ADMINISTRATIVE AMENDMENT (PD) ADD2024-00012

ADMINISTRATIVE AMENDMENT
LEE COUNTY, FLORIDA

WHEREAS, Hole Montes, Inc. filed an application for an administrative amendment for lake restoration to a Residential Planned Development on a project known as Cross Creek Estates to:

CONSTRUCTION PLANS FOR CROSS CREEK ESTATES LAKE BANK RESTORATION

Exhibit C

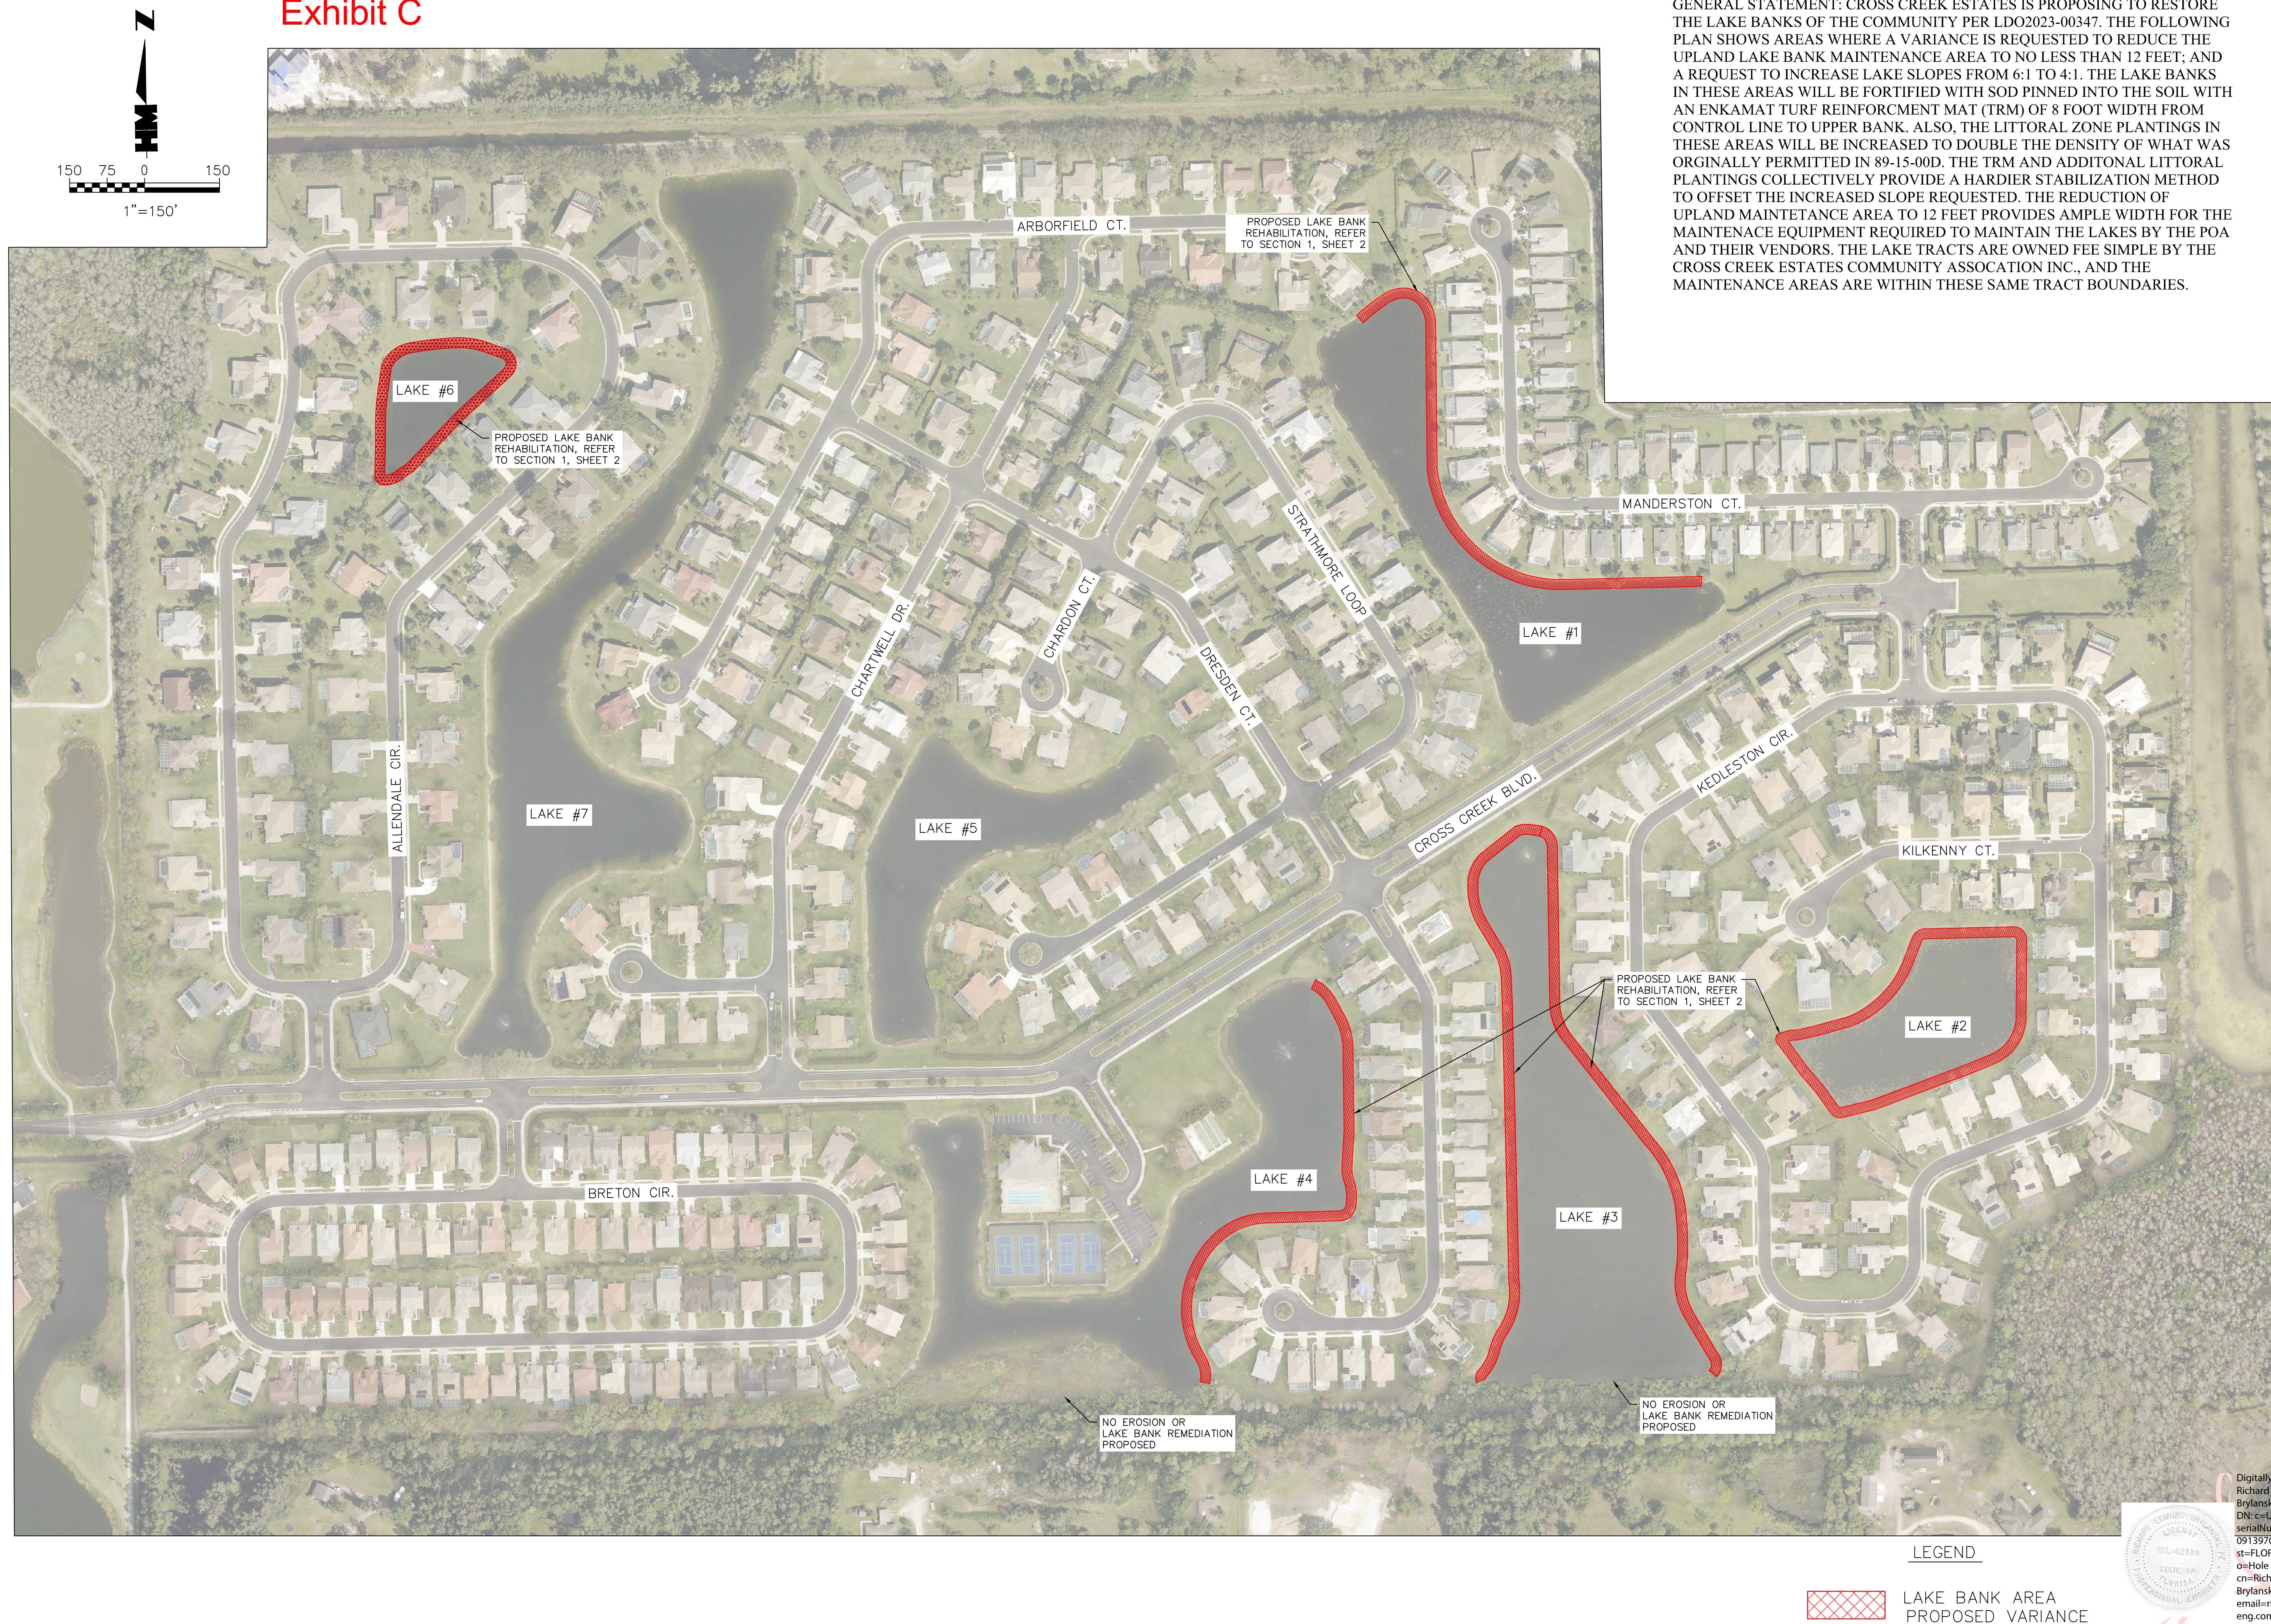
WHEREAS, the applicant has requested Deviation #18 from LDC Section 10-329(d)(4) to allow a 4:1 lake bank slope along certain segments of lakes within the planned development where a 6:1 slope is required (see Exhibit C); and

WHEREAS, the applicant has requested Deviation #19 from LDC Section 10-328(a) to allow a 12-foot-wide lake maintenance easement along the areas where a 4:1 lake bank slope is proposed (see Exhibits C and D); and

GENERAL STATEMENT: CROSS CREEK ESTATES IS PROPOSING TO RESTORE THE LAKE BANKS OF THE COMMUNITY PER LDO2023-00347. THE FOLLOWING PLAN SHOWS AREAS WHERE A VARIANCE IS REQUESTED TO REDUCE THE UPLAND LAKE BANK MAINTENANCE AREA TO NO LESS THAN 12 FEET; AND A REQUEST TO INCREASE LAKE SLOPES FROM 6:1 TO 4:1. THE LAKE BANKS IN THESE AREAS WILL BE FORTIFIED WITH SOIL PINNED INTO THE SOIL WITH AN ENKAMAT TURF REINFORCEMENT MAT (TRM) OF 8 FOOT WIDTH FROM CONTROL LINE TO UPPER BANK. ALSO, THE LITTORAL ZONE PLANTINGS IN THESE AREAS WILL BE INCREASED TO DOUBLE THE DENSITY OF WHAT WAS ORIGINALLY PERMITTED IN 89-15-00D. THE TRM AND ADDITIONAL LITTORAL PLANTINGS COLLECTIVELY PROVIDE A HARDIER STABILIZATION METHOD TO OFFSET THE INCREASED SLOPE REQUESTED. THE REDUCTION OF UPLAND MAINTENANCE AREA TO 12 FEET PROVIDES AMPLE WIDTH FOR THE MAINTENANCE EQUIPMENT REQUIRED TO MAINTAIN THE LAKES BY THE POA AND THEIR VENDORS. THE LAKE TRACTS ARE OWNED FEE SIMPLE BY THE CROSS CREEK ESTATES COMMUNITY ASSOCIATION INC., AND THE MAINTENANCE AREAS ARE WITHIN THESE SAME TRACT BOUNDARIES.

2. **Deviations #18 and #19 are APPROVED with the following condition:**
 - a. **Prior to development order approval, the lake bank restoration is limited to Lakes 1-4 and Lake 6 in accordance with Exhibit C.**

Exhibit D

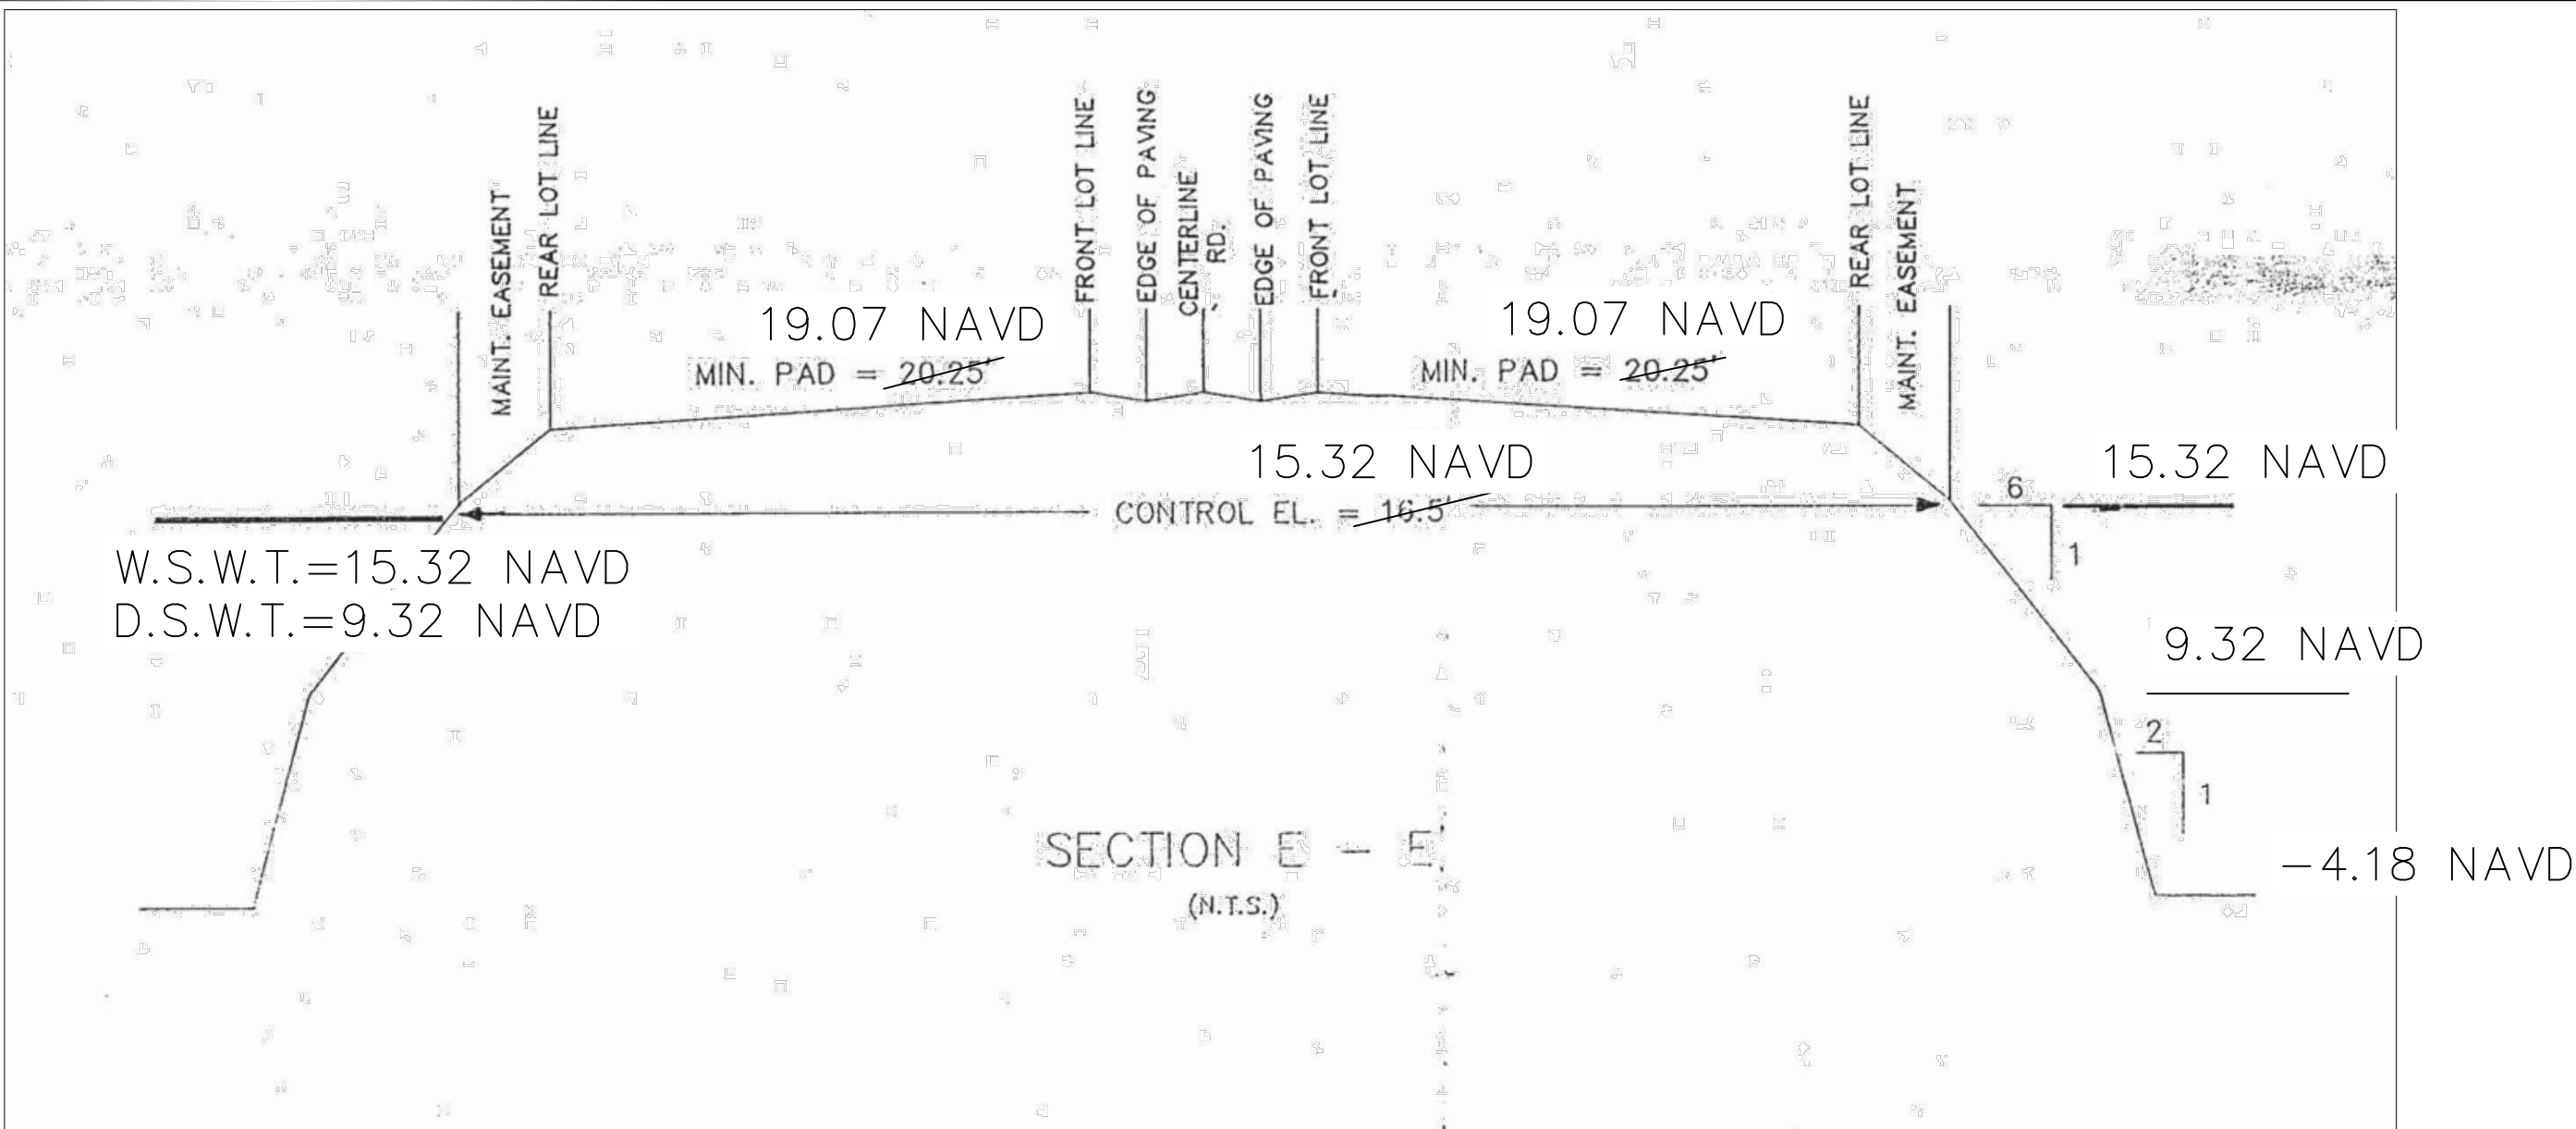
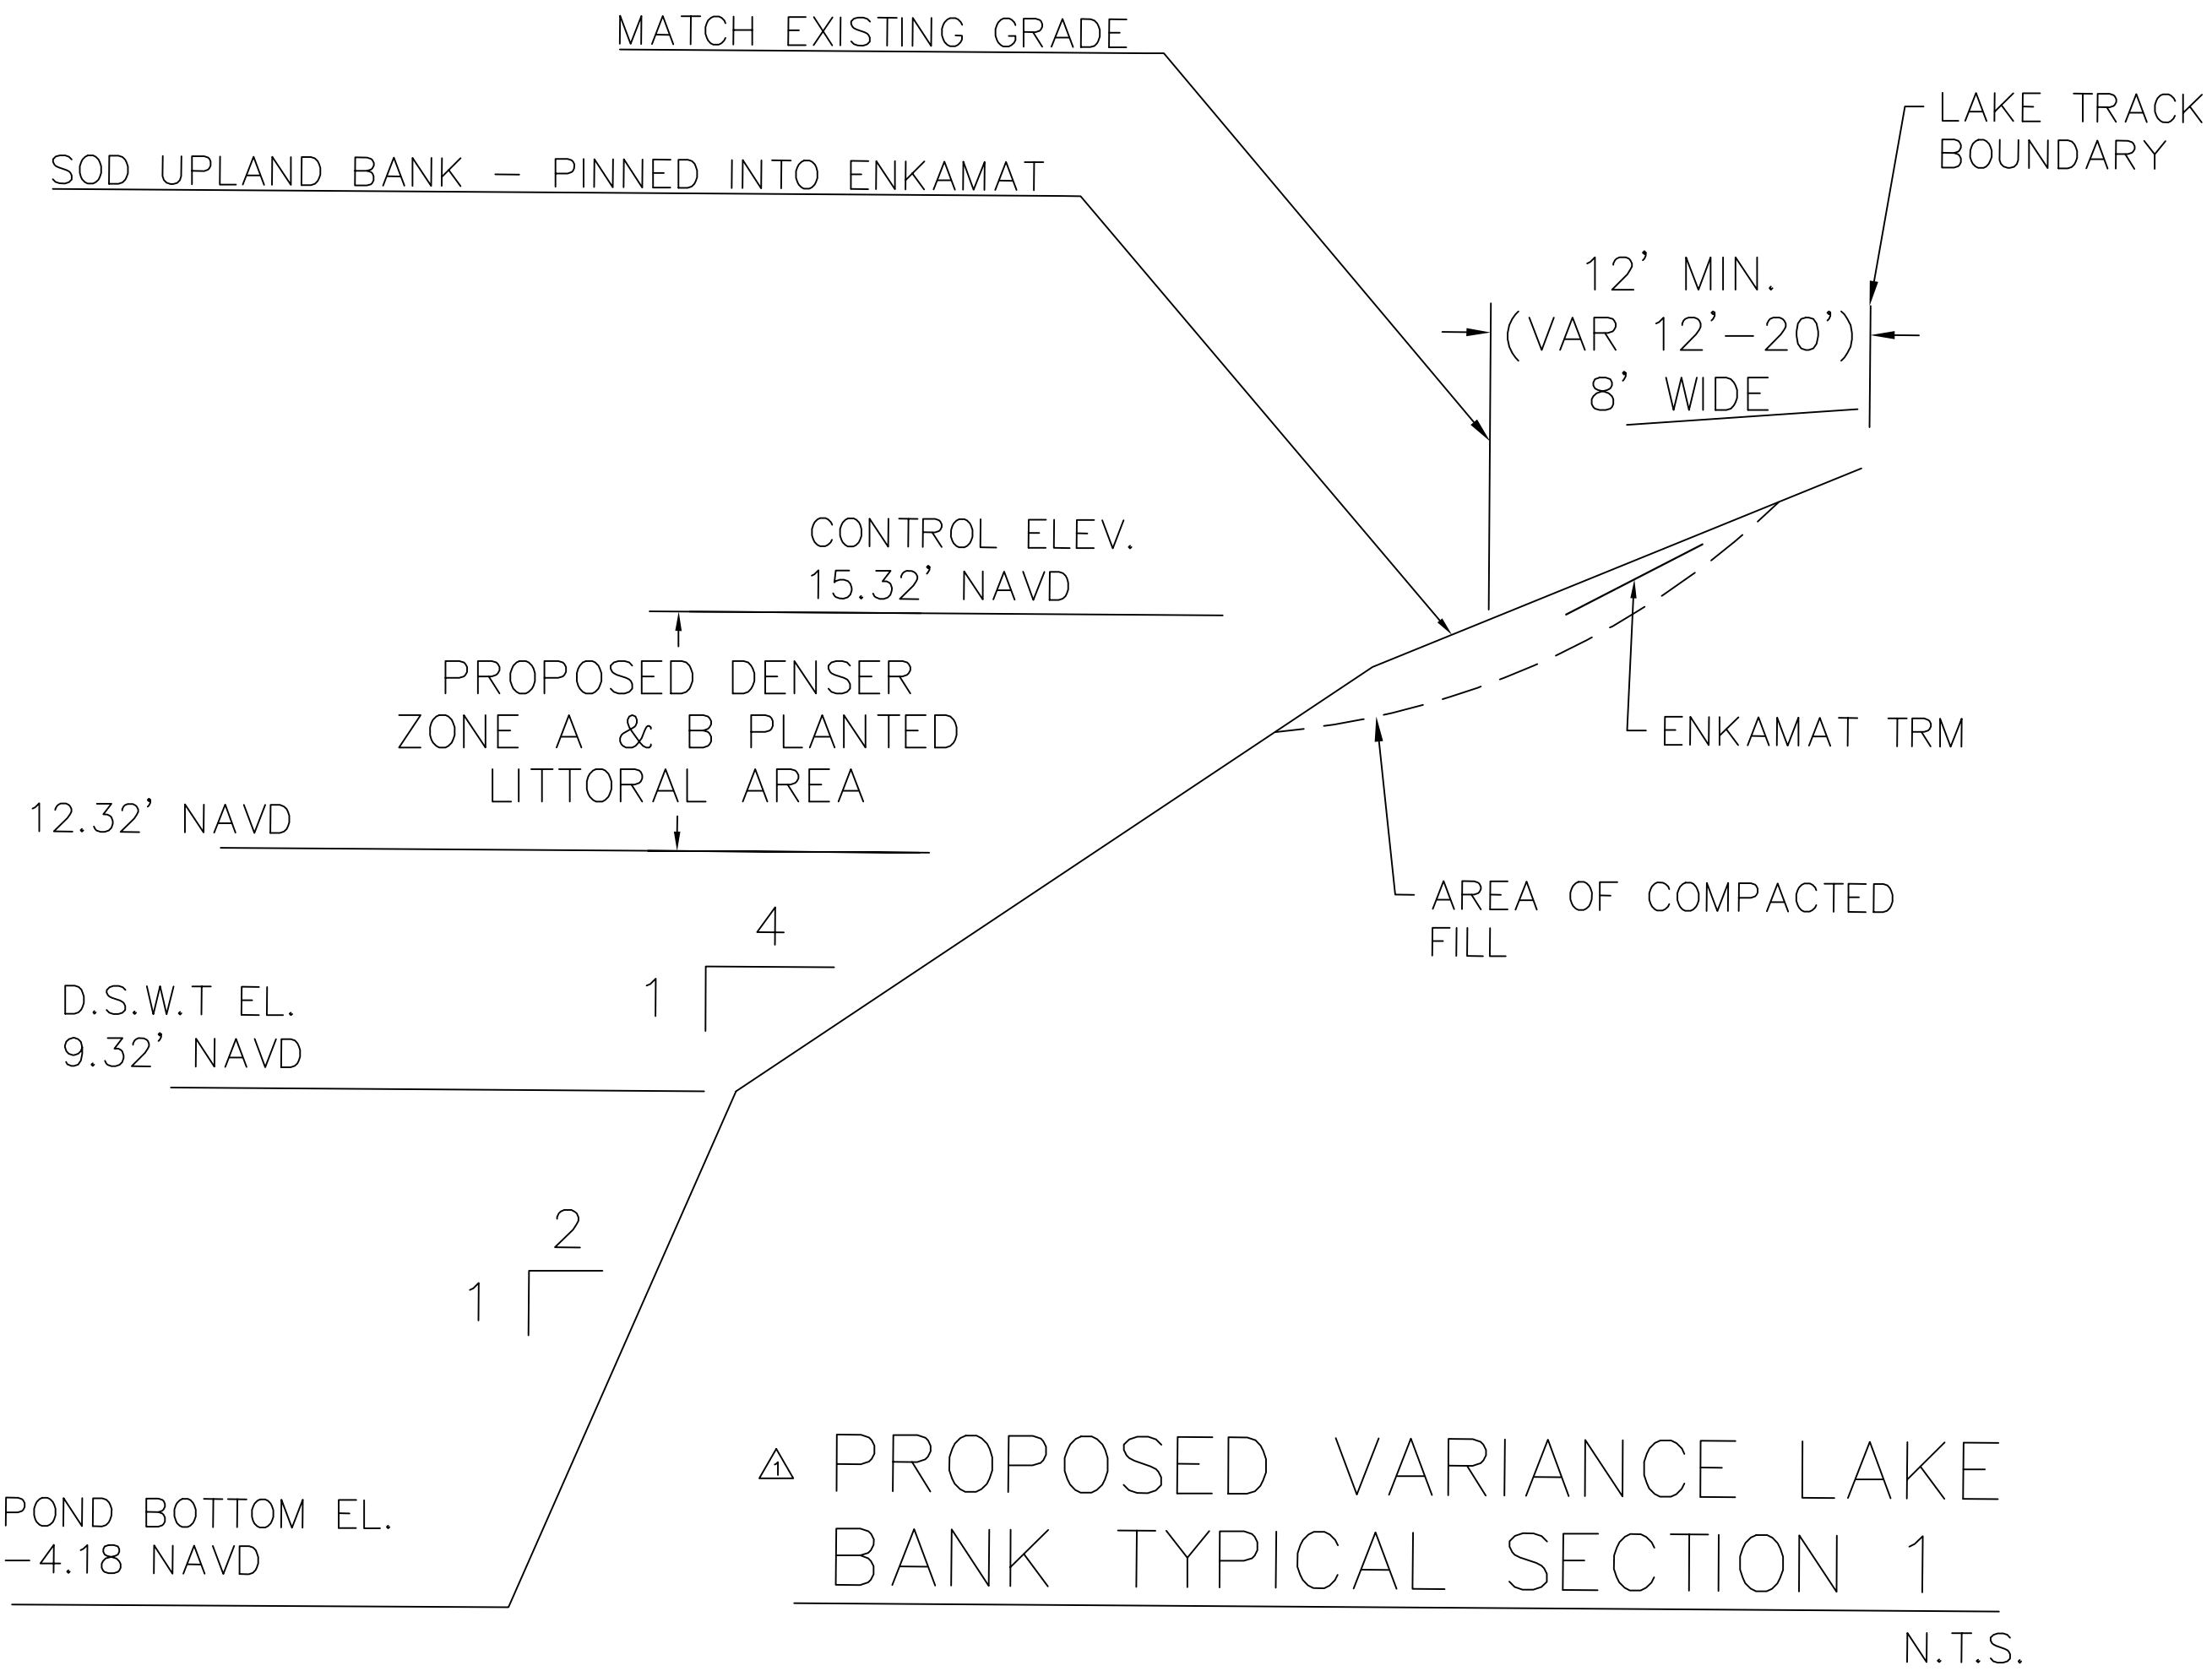
WHEREAS, the applicant has indicated that the 4:1 lake bank slope will be stabilized by compacted fill, turf reinforcement mats, and enhanced littoral plants (Exhibit D); and

1. **The restoration of the existing lakes must be in compliance with the amended Lake Bank Restoration Cross Section and Littorals Exhibit dated March 5, 2024, a reduced copy of which is attached hereto as Exhibit D.**
